## U.S. Helicopter Safety Team / Infrastructure Working Group (USHST/IWG)

**DATE:** October 2, 2018

**RE:** Recommendations for the FAA Heliport Design Guide, FAA AC 150/5390-2C

**Figure 2-24**

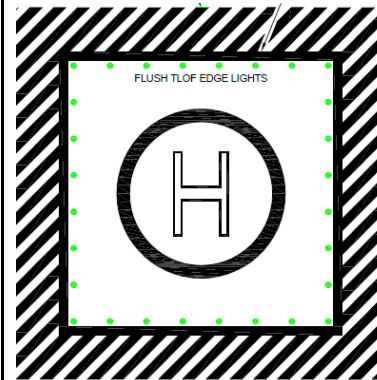
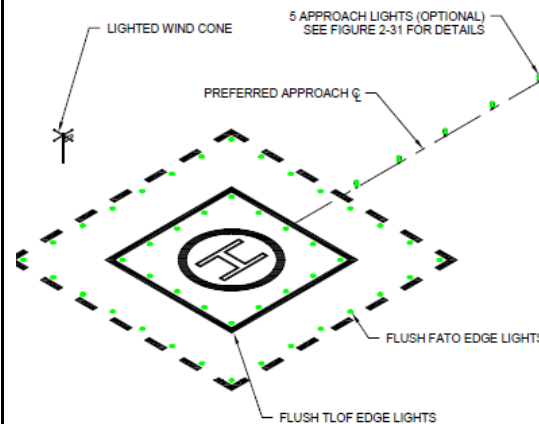
8.	<p><b>Update advisory circular heliport lighting diagrams.</b></p>	<p style="text-align: center;"><b>DISCUSSION:</b></p> <p>Recommend updating heliport diagrams in the design guide that depict lighting to more accurately reflect the required number of lights as specified in the advisory circular in writing.</p> <p>Oftentimes lighting manufactures convince heliport owners and designers to purchase large quantities of lighting which they do not need based on the errors currently found in the illustrations of the heliport design guide.</p> <p>Examples:</p> <p>Figure 2-24 shows 28 lights around a TLOF for which eight (8) lights would have worked. At a cost, in some cases, of upwards of \$800 dollars per light, this represents a savings of upwards of \$16,000.00 for materials which does not include wiring and labor.</p>	<p style="text-align: center;"><b>JUSTIFICATION:</b></p> <p>This would reduce the potential overall cost of a heliport, allowing limited funds to be better spent on more appropriate safety enhancements.</p> <p>From an overall safety standpoint, at locations where a large number of unnecessary lighting has been installed, it can overwhelm a pilot's vestibular system hence creating the potential for an optical illusion to occur during a critical phase of flight by creating a dazzle effect.</p> <p>This would also move to bring the heliport design guide in line with the requirements specified in Part-135 for marking and lighting of landing areas.</p>

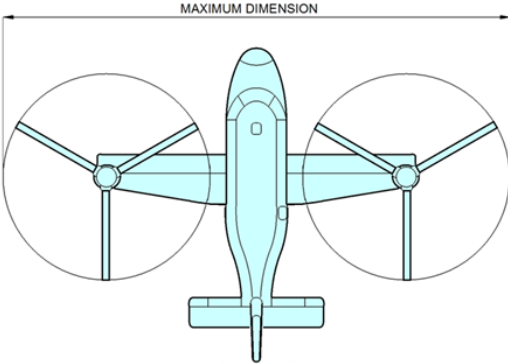
12.	<p><b>Reevaluate the heliport information box dimensions and layout.</b></p>	<p style="text-align: center;"><b>DISCUSSION:</b></p> <p>In the current heliport design guide Fig 2-23 shows a 5 FT square Limitation box. This has been shown to be hard for pilot to read until they are very close to the heliport.</p> <p>Recommend expanding the limitations box to 10 FT square when possible and reduce the dimensions of the</p>	<p style="text-align: center;"><b>JUSTIFICATION:</b></p> <p>Provide higher visibility and improved readability at a greater distance regarding a heliports size and weight limitations to pilots prior to landing. Hence enhancing safety.</p>

<p>information box proportionally as needed for smaller heliports if needed.</p> <p>Fig 2-23</p>  <p>Heliports supporting commercial operations and all rooftop heliports should always be marked with the appropriate information in a limitations box.</p> <p>It would be prudent to check with the FAA test center to see if there is any research regarding this topic.</p>	
<p>13.</p>	<p><b>Include sectored app/dep paths in airspace design options.</b></p>	<p><b>DISCUSSION:</b></p> <p>Recommend including an option along with design criteria for designating a sectored app/dep path, e.g. between 090° to 230° in lieu of a specific app/dep path of 090/180.</p> <p>Currently, some FAA inspectors are creating sectored app/dep zones in lieu of a specific app/dep path but there is no standard that defines how this is to be done.</p> <p>This information will need to be addressed in the FSIMS 8900.1</p> <p>Additionally, given a sectored app/dep zone is utilized a heliport marking should be incorporated that reflects that</p>	<p><b>JUSTIFICATION:</b></p> <p>This would help to standardize and codify a practice currently being used in the field by FAA inspectors.</p> <p>It would also allow heliport proponents the capability to take advantage of this practice when they do have the available airspace to accomplish a sectored app/dep zone.</p>
